**RE: TRIPOLI WAY STAGE 1 EXTENSION
AVIATION IMPACT STATEMENT**

REHBEIN Airport Consulting has reviewed the Tripoli Way Extension - 80% Complete Concept Design prepared by Cardno (6 May 2020) against the relevant National Airports Safeguarding Framework (NASF) Guidelines. The design information was provided in PDF format as follows:

Project:
**TRIPOLI WAY EXTENSION
 AVIATION ASSESSMENT**

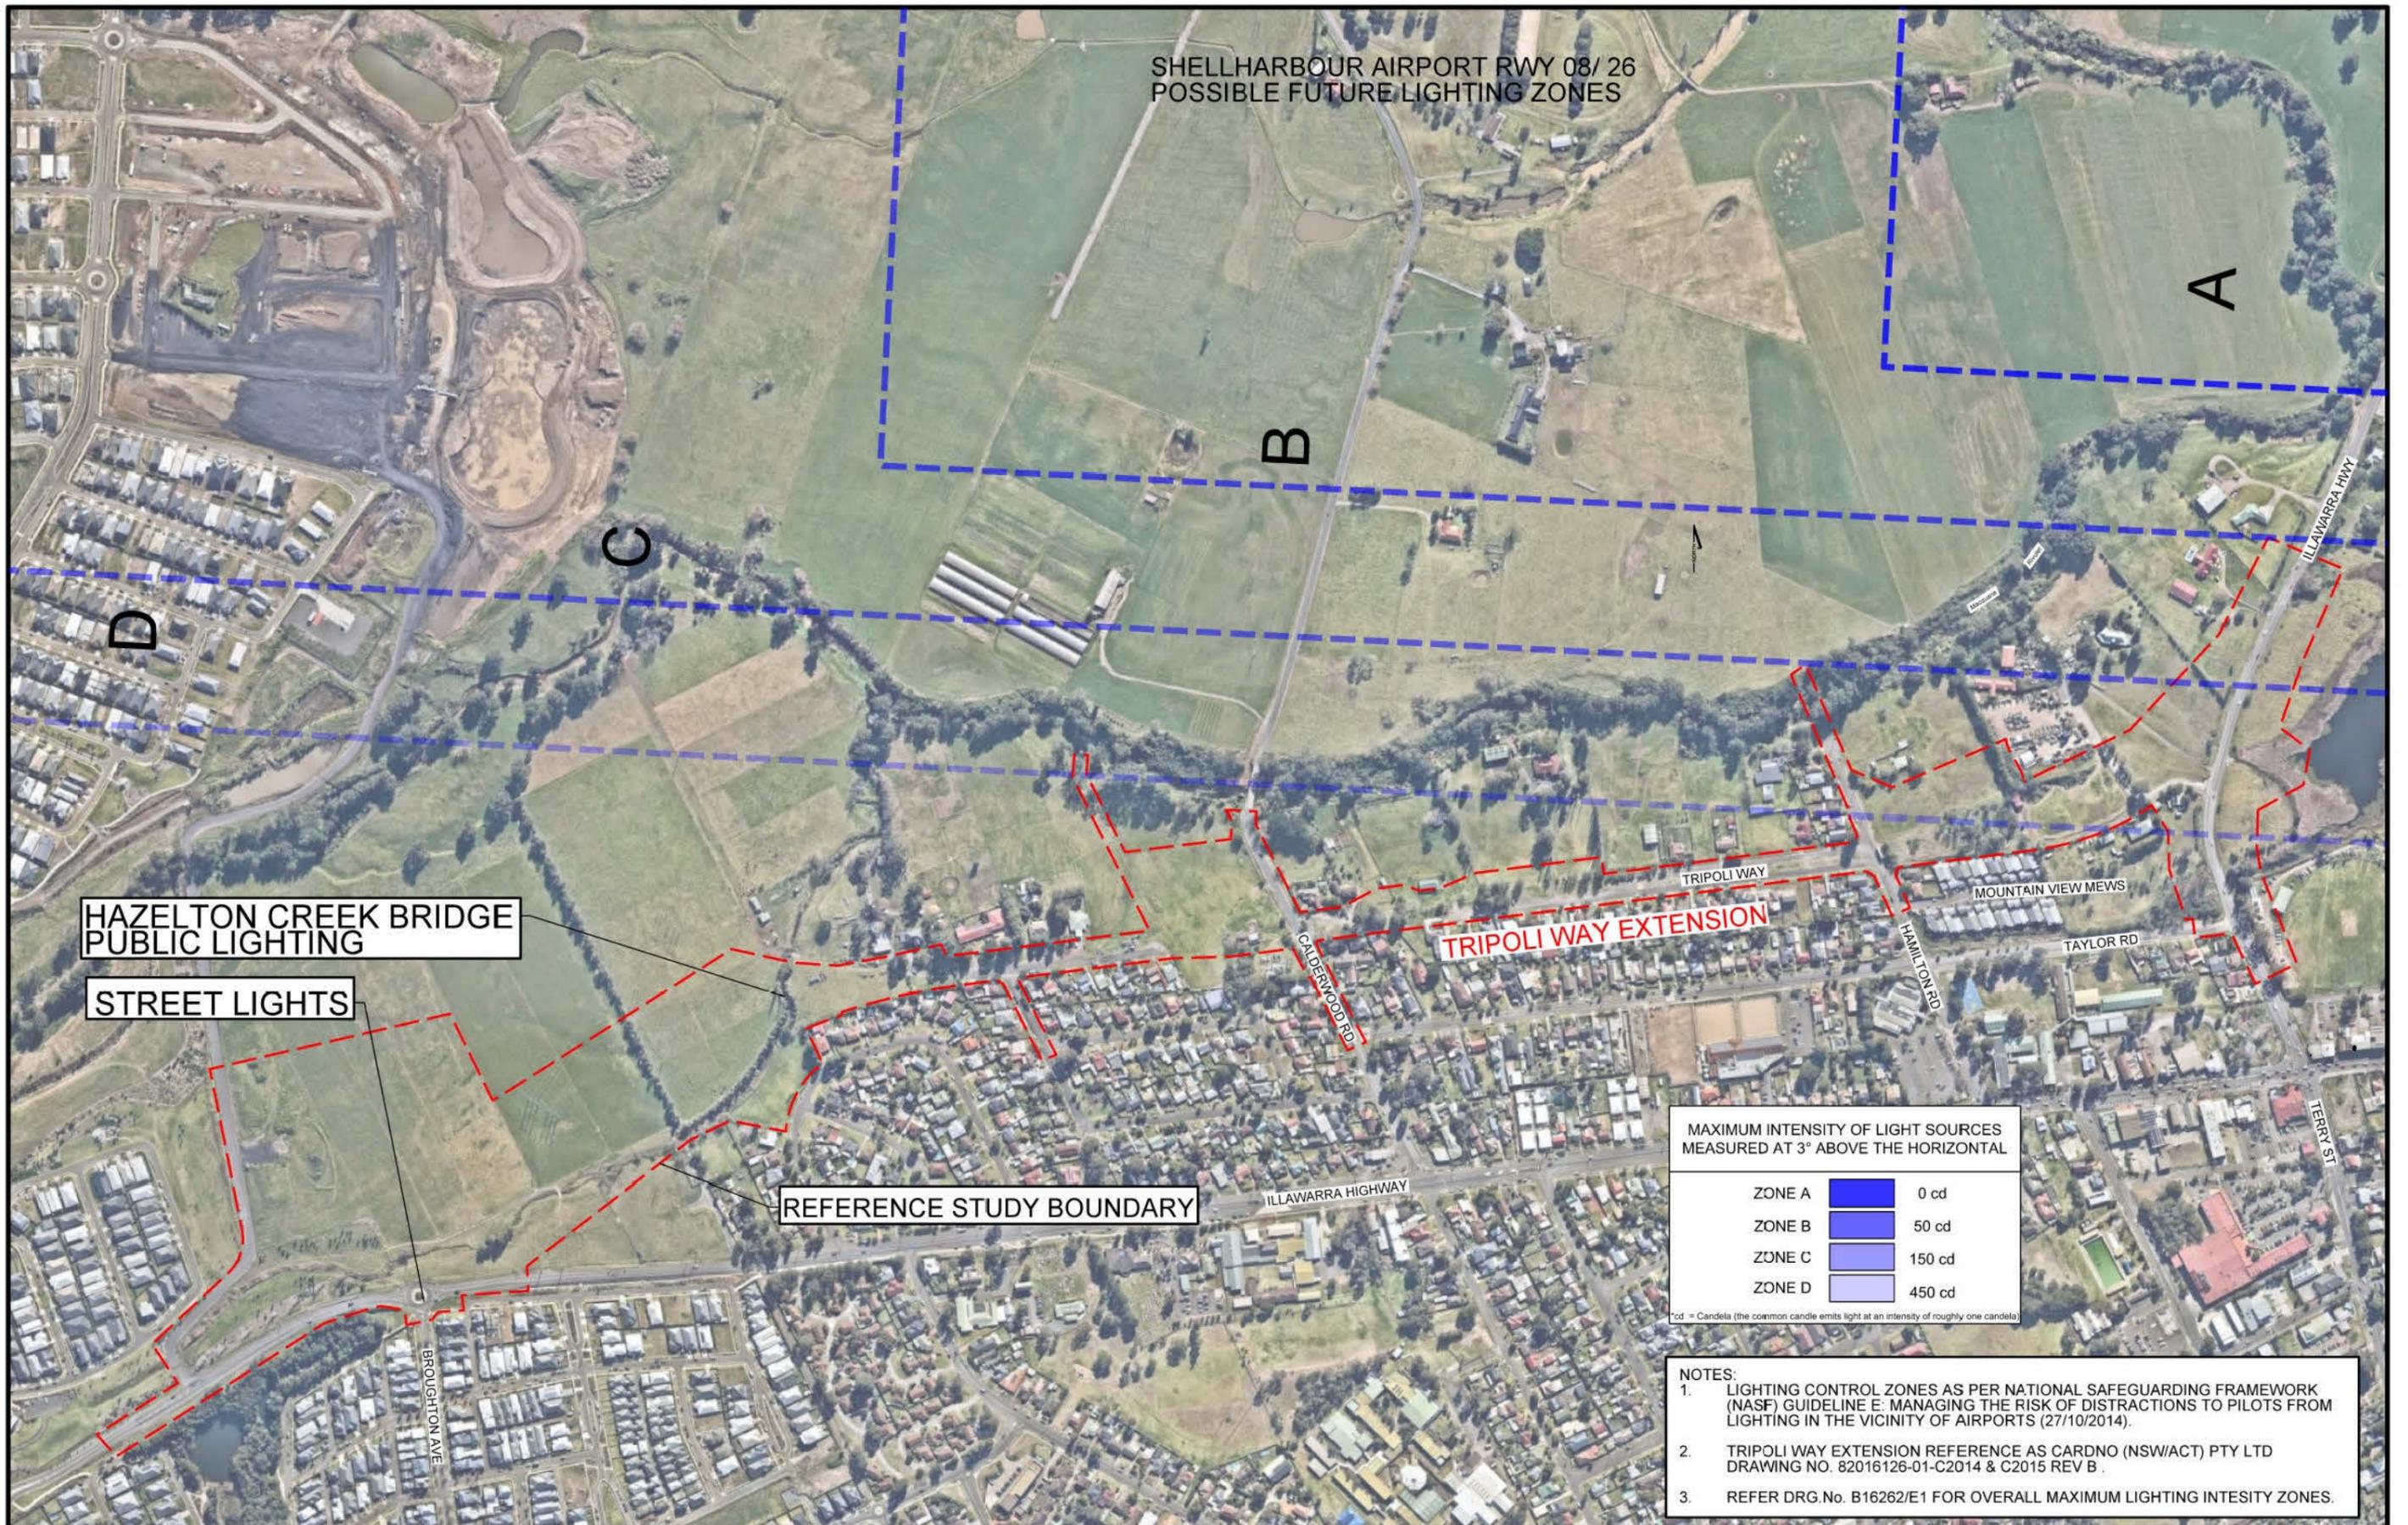
The public lighting columns illustrated on the bridge over Hazelton Creek and the existing street lights at the intersection of the Illawarra Highway and Broughton Avenue are outside of the lateral extents of the Runway 08/26 possible future lighting restriction zones as illustrated on **Figure B16262/E2**.

The easternmost section of the Tripoli Way Extension, from approximately Hamilton Road east to and along the Illawarra Highway is within the Runway 08/26 possible future light control zones C and D as illustrated on **Figure B16262/E2**. Zone C allows for a

maximum intensity of light sources, measured at 3 degrees above the horizontal, to be 150 candela (cd). Zone D allows for 450 cd. It is recommended that, to the extent practical the Zone C and D restrictions be taken into account in the final lighting design.

Figure No		A3
B16262/1		
Scale 120,000		Sheet Size
0	19.06.20	
Rev	Date	File Ref B16262

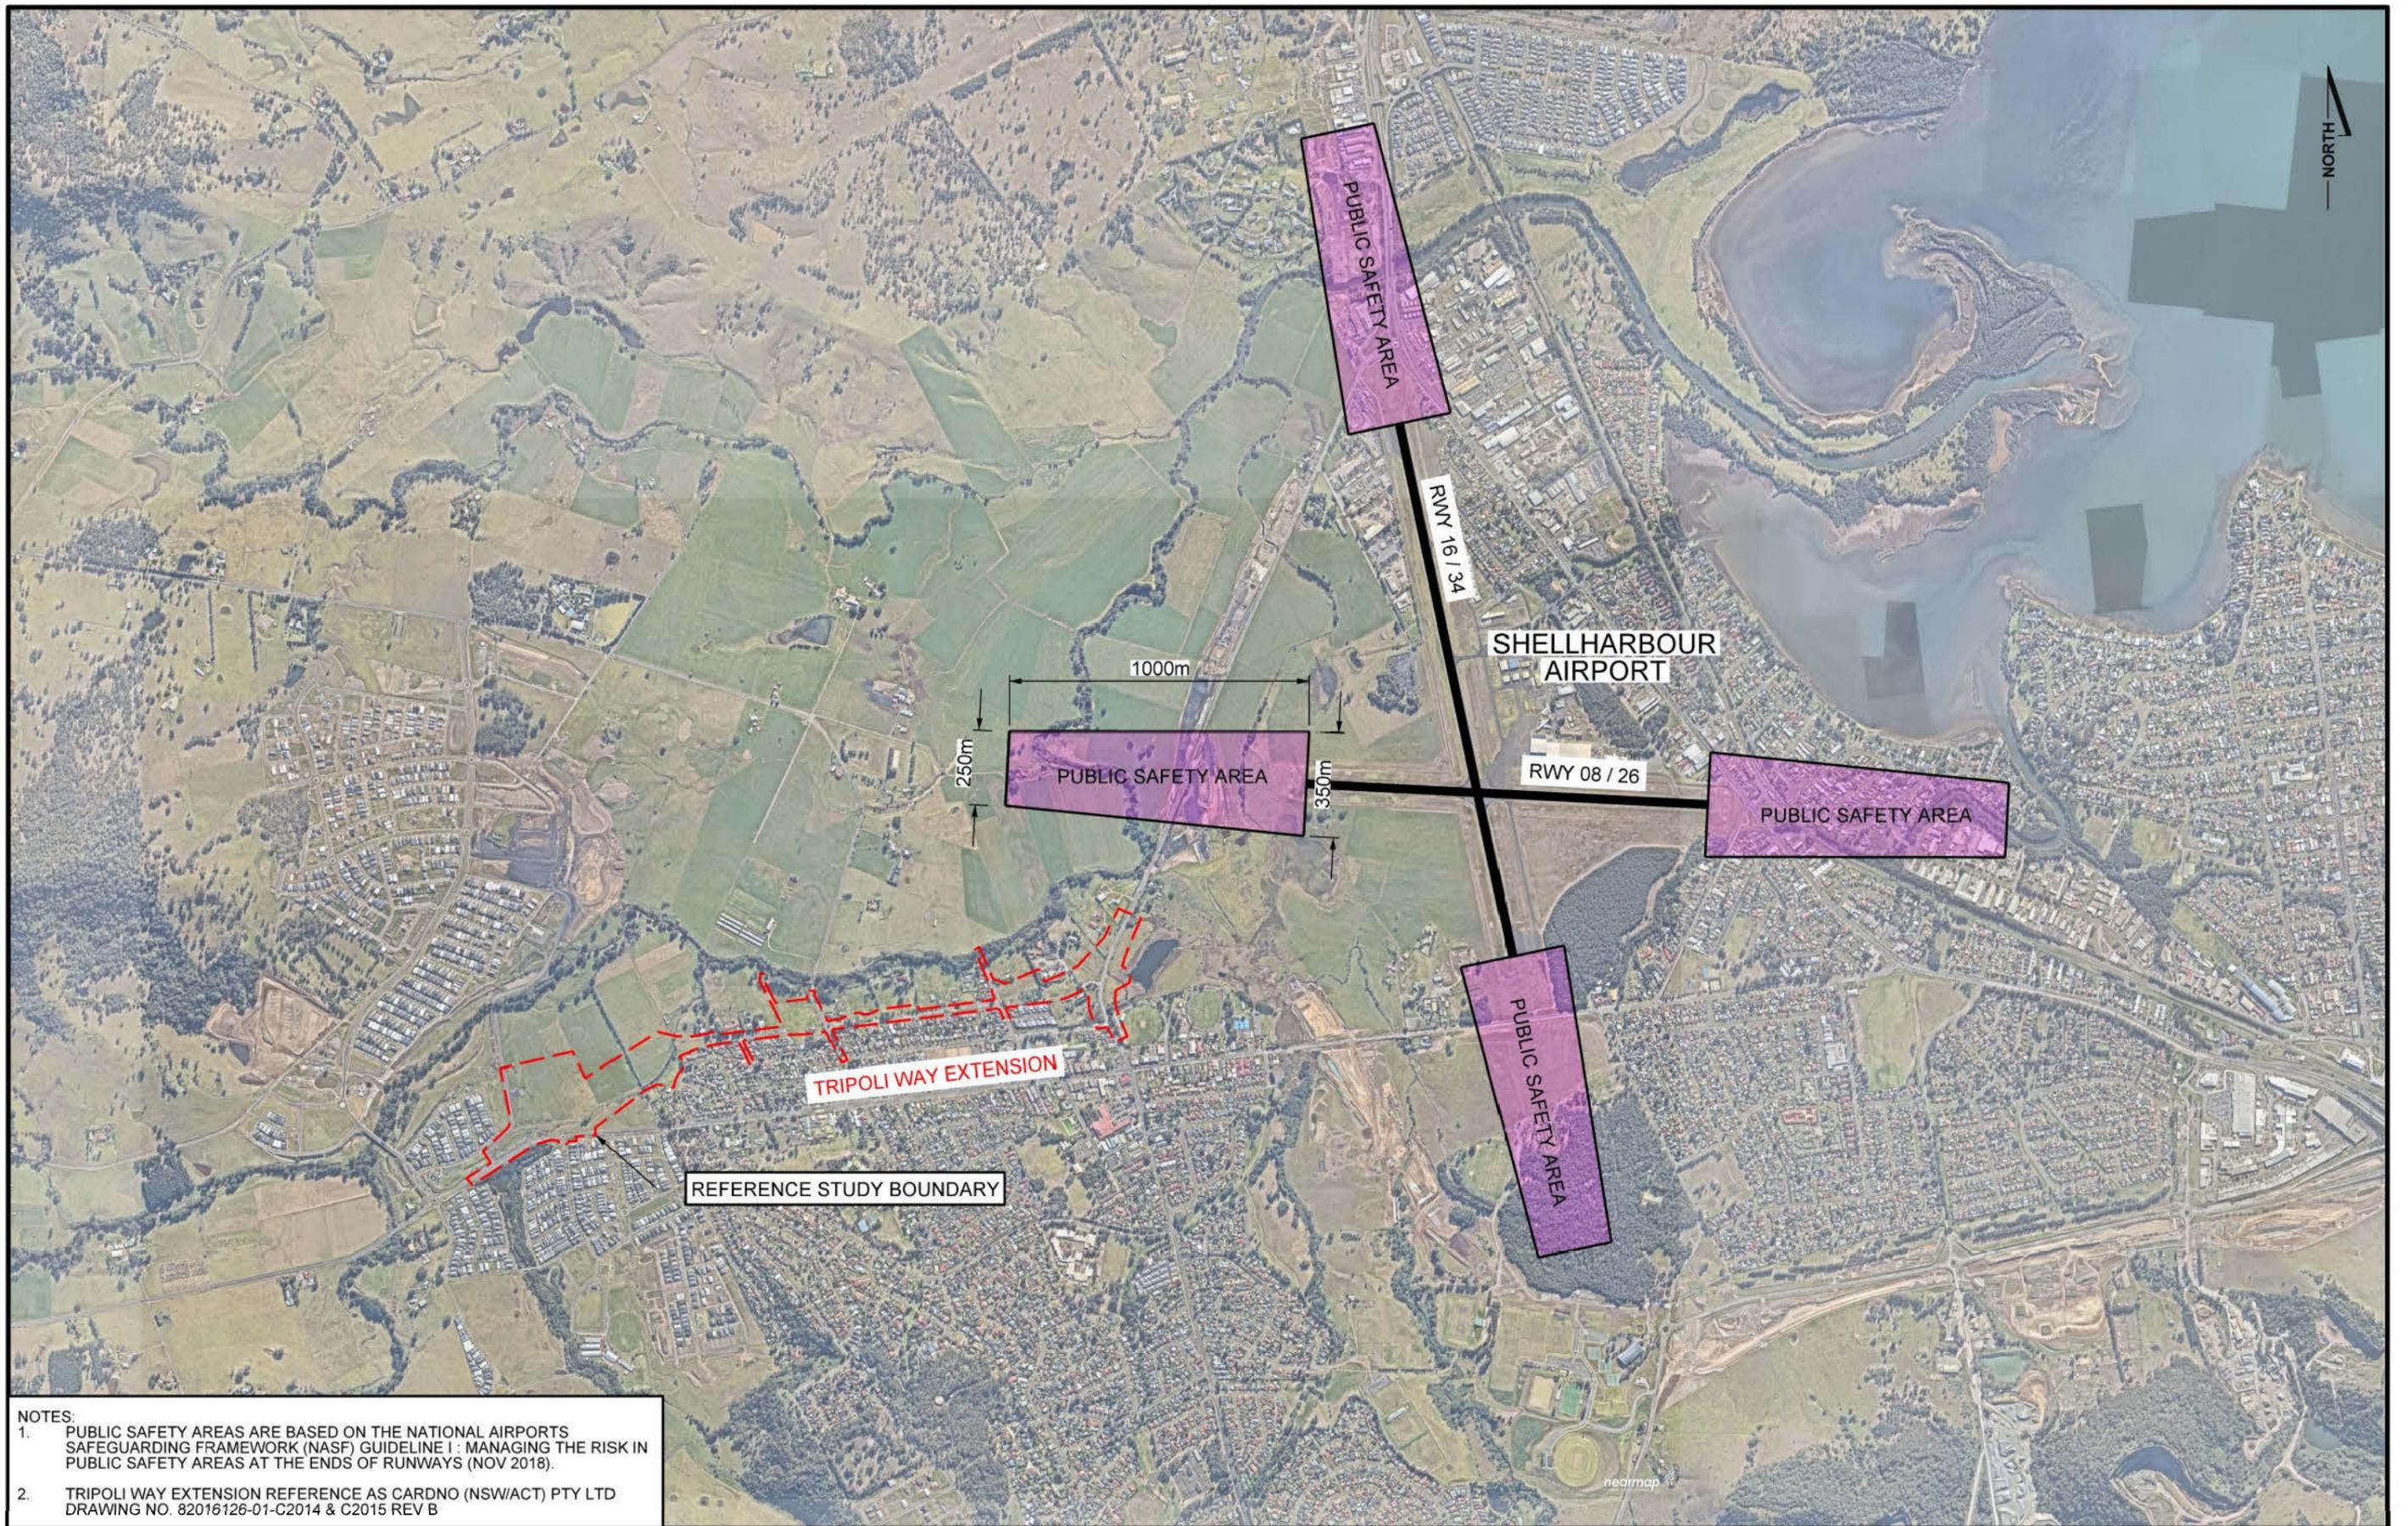
The Tripoli Way Extension is not within the PSAs when defined using the Queensland State Planning Policy PSA Model as described in Attachment 2 to the Guideline and illustrate on **Figure B16262/I**.
